AGENDA
DANIA BEACH CITY COMMISSION
REGULAR MEETING
TUESDAY, JANUARY 23, 2018 - 7:00 PM

A3.04

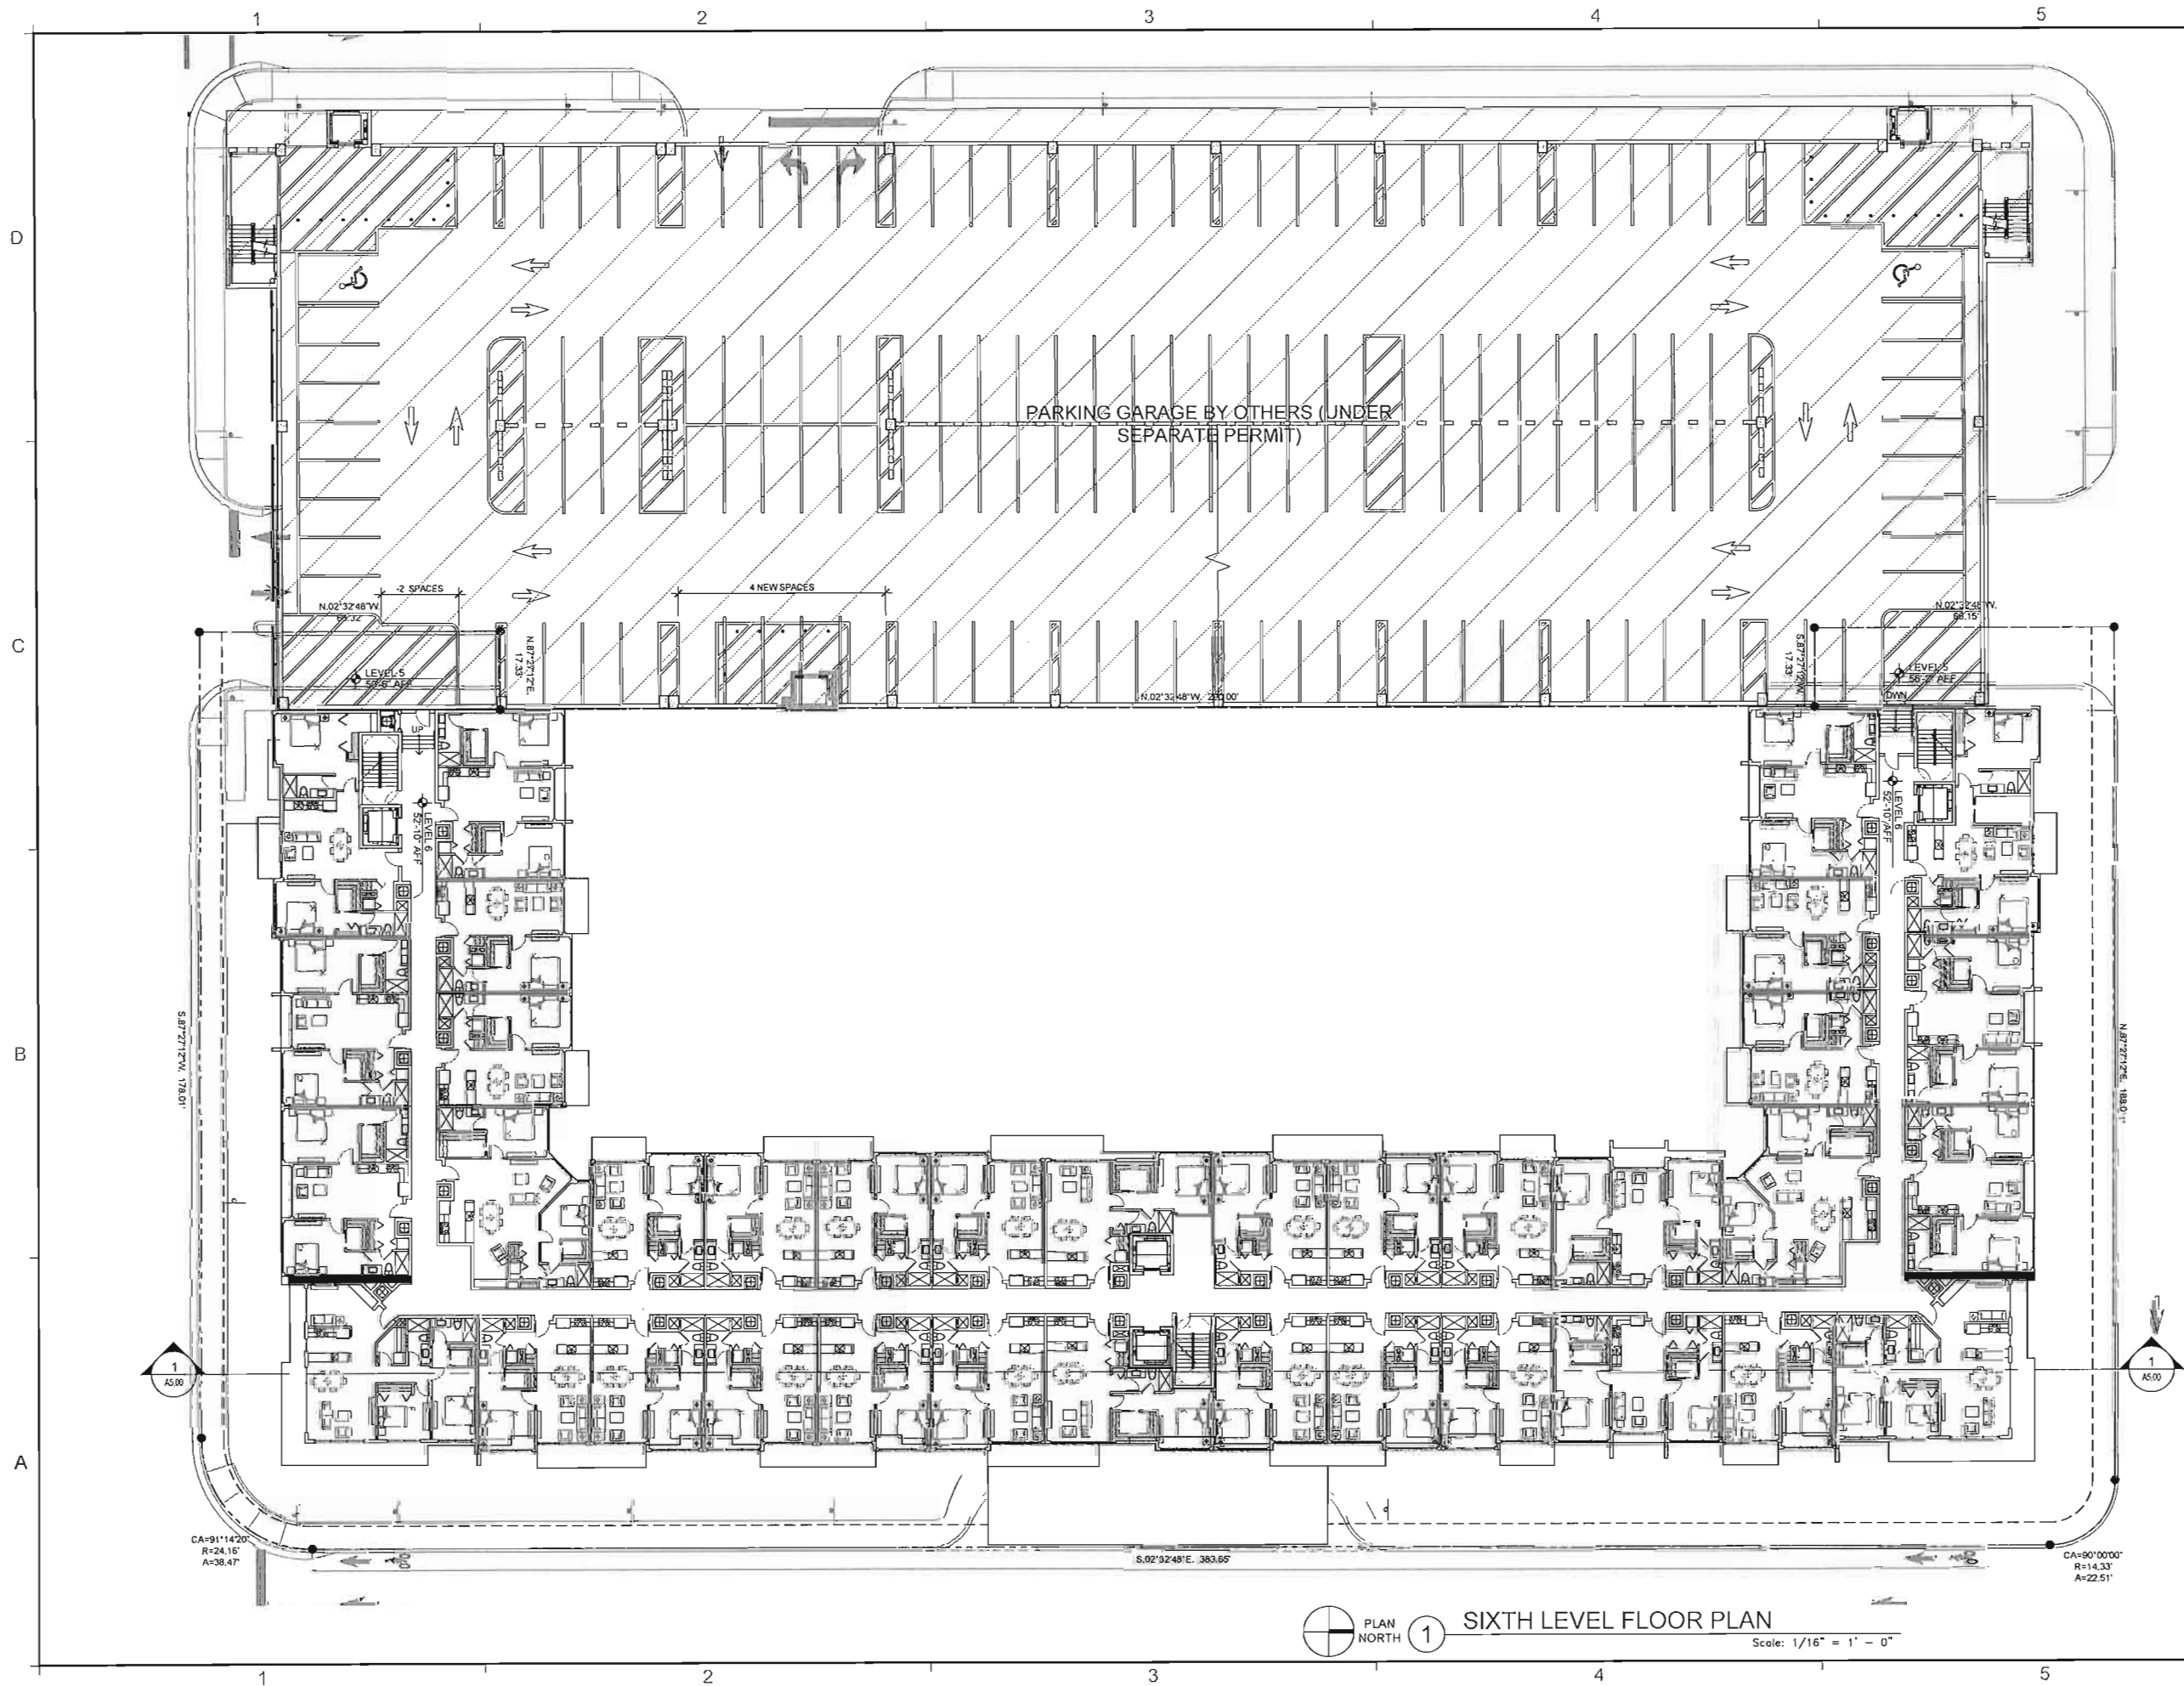
17. The parking calculations provided on Sheet C-402 does not match the drawings provided on Sheets A3.01 – A3.06. For example, only 136 parking spaces + 2 ADA spaces are shown on Sheet A3.04; Sheet C-402 identified 141 parking spaces. I believe this is true for each level. Revise accordingly (Planning).

21. The parking calculations provided on Sheet C-402 does not match the drawings provided on Sheets A3.01 – A3.06. For example, only 136 parking spaces + 2 ADA spaces are shown on Sheet A3.04; Sheet C-402 identified 141 parking spaces. I believe this is true for each level. Revise accordingly.

L-4

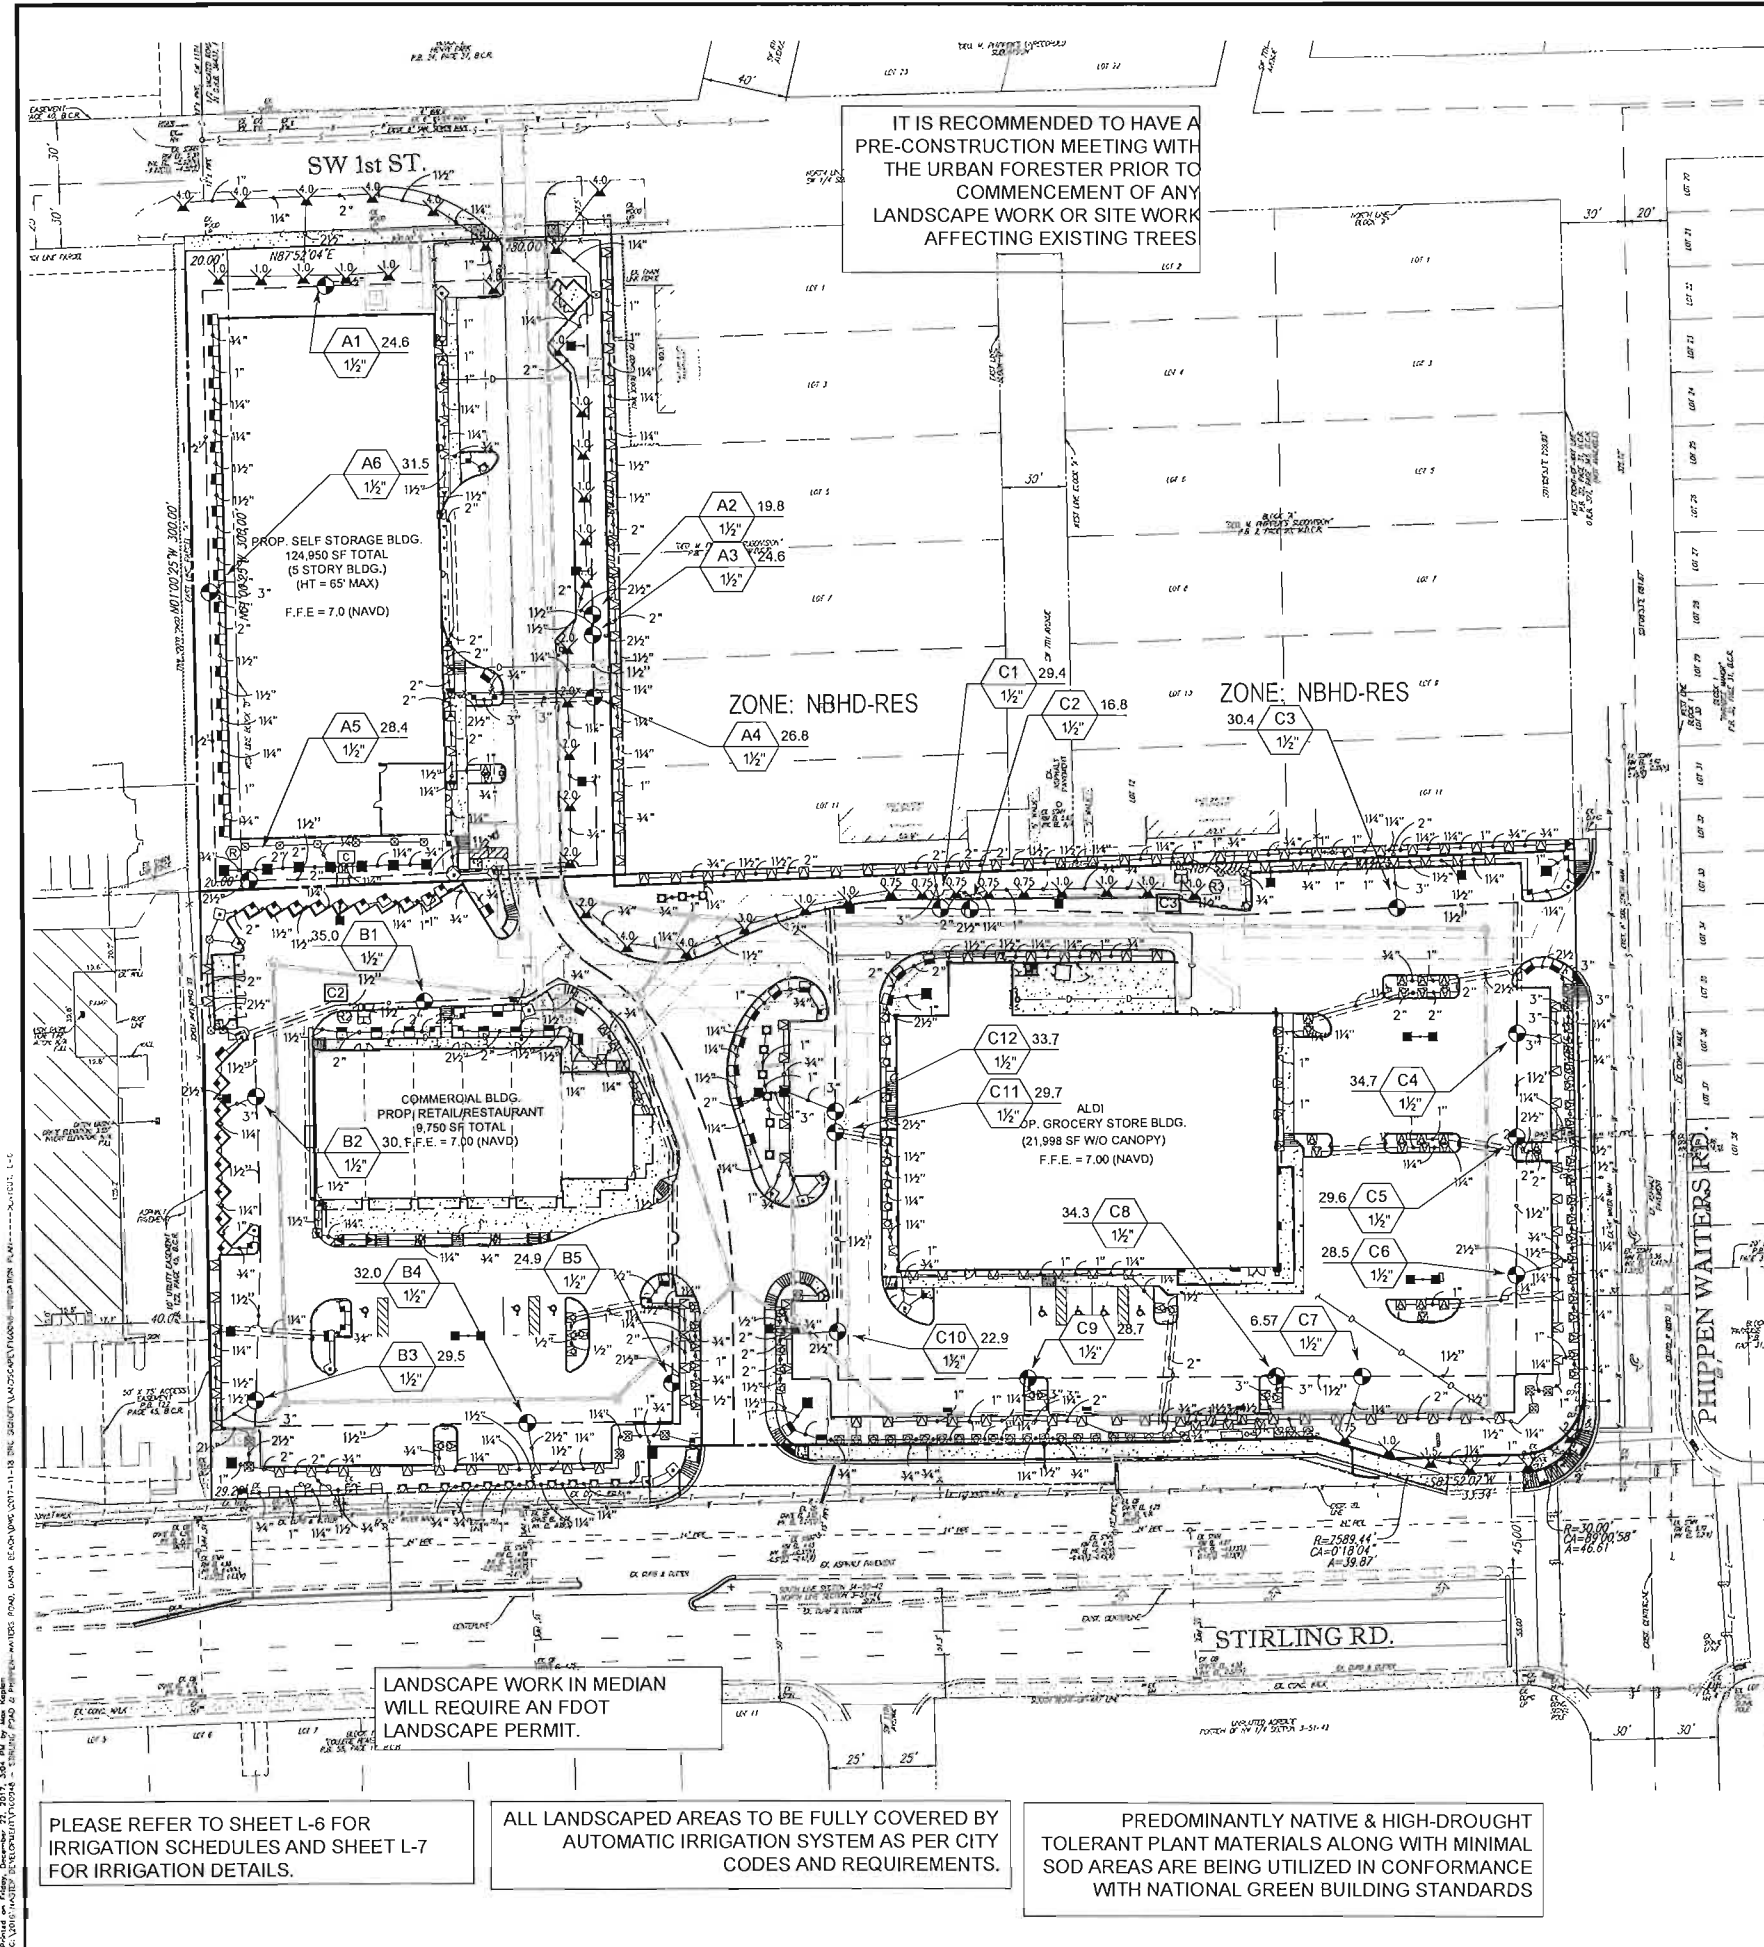
8. Provide a clarification on sheet L-4 that the finished grade of all landscape areas within and adjacent to VUA will be at or below the final VUA grade per Sec. 275-190(N) (Landscape).

8. Provide a clarification on sheet L-4 that the finished grade of all landscape areas within and adjacent to VUA will be at or below the final VUA grade per Sec. 275-190(N) (Landscape).

6. Provide a clarification on sheet L-4 that the finished grade of all landscape areas within and adjacent to VUA will be at or below the final VUA grade per Sec. 275-190(N).
